Determination 2016/038

Regarding the code-compliance of weatherboards to a partly constructed house at 28 Roberta Drive, Spreydon, Christchurch

Summary

Figure 1: Wall claddings

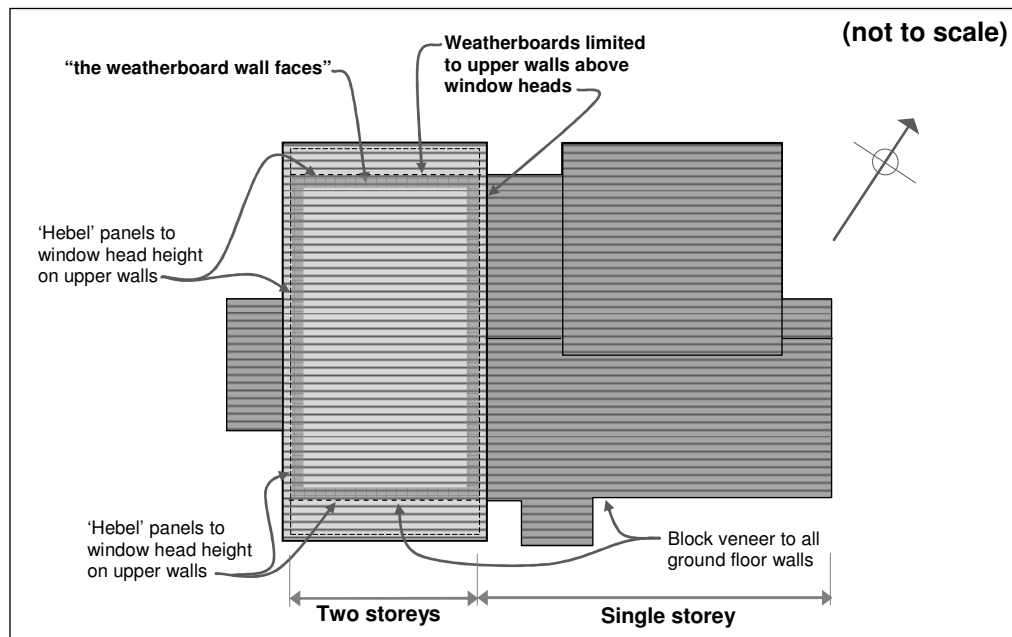
6.3.1 In this instance, the subject weatherboard cladding is limited to upper walls on the two-storey portion of the house as shown in Figure 1 and the weathertightness risk can be assessed for those wall faces ("the weatherboard wall faces") independently of the remainder of the house.

- the wall faces are in a medium wind zone
- weatherboards to one wall face are positioned above another cladding on a cavity, which extends down to a roof/wall junction
- there are limited roof overhangs to shelter the weatherboards

- the weatherboard wall faces are simple in plan and form
- the weatherboards are fixed over a drained cavity and above other claddings that incorporate cavities
- apart from the holding brads, the weatherboards are fixed to good trade practice
- the external wall framing is treated to a level that provides resistance to decay if it absorbs and retains moisture.

6.3.5 When evaluated using the E2/AS1 risk matrix, the weathertightness features outlined in paragraph 6.3.3 show that the subject wall faces demonstrate a low weathertightness risk rating. I note that, if the details shown in E2/AS1 were adopted to show code-compliance, the weatherboard cladding to those wall faces would not require a drained cavity.

Figure 2: Weatherboard fixings

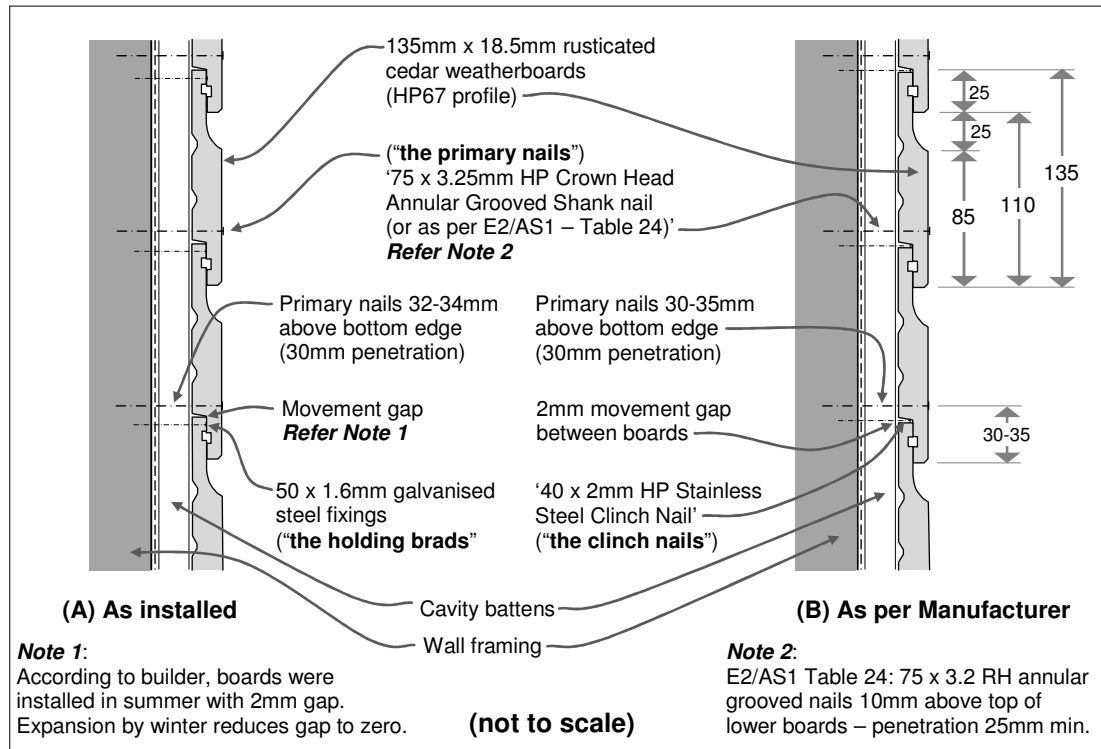
- Sketch 2(A): during installation, boards were held in place using the holding brads to allow set out prior to being fixed with the primary nails. The holding brads are 50 x 1.6mm galvanised steel nails fixed through the top of the boards into every second cavity batten.

- Note 1 to Figure 2(A): the weatherboards appear to have been installed in about December 2015 and the builder has stated that a 2mm movement gap was included, with expansion of the boards up to the time of the expert's inspection (June 2016) taking up that gap (see paragraph 3.3).

- Sketch 2(B): the manufacturer specifies 40 x 2mm stainless steel clinch nails, which allow board set out prior to being fixed with the primary nails. The clinch nails are positioned in the 2mm movement gap between boards and are shaped to hold the top of the board in place without penetrating its surface.

- Note 2 to Figure 2(B): the Acceptable Solution E2/AS1 calls for primary nails to be RH grooved nails that miss the lower board and penetrate through the battens and into framing by a minimum of 25mm, with the nail positioned 10mm above the top of the lower board.

- The primary nails were 75 x 3.25mm grooved crown head stainless steel positioned so that they missed the top of the underlying board.
- The holding brads were 50 x 1.65mm zinc-plated (galvanised) steel, fixed into the tongue above the weathergroove.
- The holding brads appeared to be fixed into every second cavity batten, and the builder advised that ‘he had only put enough brads in to hold the board while he nailed it off’.
- There was no expansion gap observed between the boards.

5.5 The expert considered that the lack of the expansion gap to the exposed area did not comply with the manufacturer’s instructions or E2/AS1, but was unable to form a view on the code compliance of the weatherboard cladding due to the limited information available.

Issue / Potential risk	Particular circumstances	Comment
Holding brads fixed to top of underlying board Splitting lower board	<ul style="list-style-type: none"> • Fixed above weathergroove of lower board. • Used as temporary holding – fixed only into every second batten • Narrower boards subject to less thermal and moisture movement than wider boards. • Cedar unlikely to be split by a small gauge nail • Any localised splitting sheltered from direct rain and protected from capillary action by overlap and grooves. 	Low risk of splitting and any splitting that might occur should not affect weathertightness or durability of cladding
Corrosion of the brad due to acidic nature of cedar	<ul style="list-style-type: none"> • Brads redundant once boards are fixed, so any corrosion has no structural affect. • Zinc will slowly deteriorate over time. • When steel substrate corrodes, red rust will form that may slowly bleed onto cedar. • Brads hidden behind 20mm overlap, so rust stains unlikely to become visible. • Maintaining oil stain will limit corrosion by limiting amount of moisture reaching brad. 	Any corrosion will not affect weathertightness or durability of cladding

Expansion gaps between boards Boards bowing and possibly splitting	<ul style="list-style-type: none"> • Builder states that 2mm movement gap was included during installation in December 2015. • Installation followed two months of warm and very dry weather, resulting in moisture levels and board dimensions expected to be close to minimum levels of seasonal variation. • Expert's inspection followed one month of very high rainfall, so moisture levels and board dimensions expected to be close to maximum levels of seasonal variation. • Boards are expected to have expanded since installation to take up movement gap. • No indication of stress in the boards to date. 	Movement gap likely to have been installed.
Warranty	Warranty may be refused as weatherboards not installed to manufacturer's instructions.	No effect on code-compliance

- 6.4.4 Taking account of the above, I have reasonable grounds to conclude that the weatherboard cladding as installed to exterior walls of this particular house and in the particular circumstances will meet the performance requirements of Clause E2.3.2, E2.3.7 and B2.3.1.
